Register Reference: SD22A/0345 **Date:** 26-Sep-2022

Location: Weston Airport, Backweston Park, Leixlip, Dublin, W23 XHF8

Applicant: Weston Aviation Academy Limited

Roads Department – Planning Report

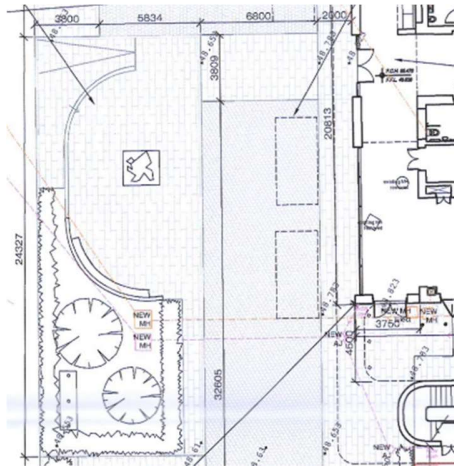
- 5% (minimum) of carpark spaces shall be allocated for mobility impaired users
 $191 \times 0.05 = 9.55$ or minimum of **10no mobility impaired carpark spaces** required
- 20% of carpark spaces shall be equipped with electrical charging points
 $191 \times 0.20 = 38.2$ or **38no EV charging points** required
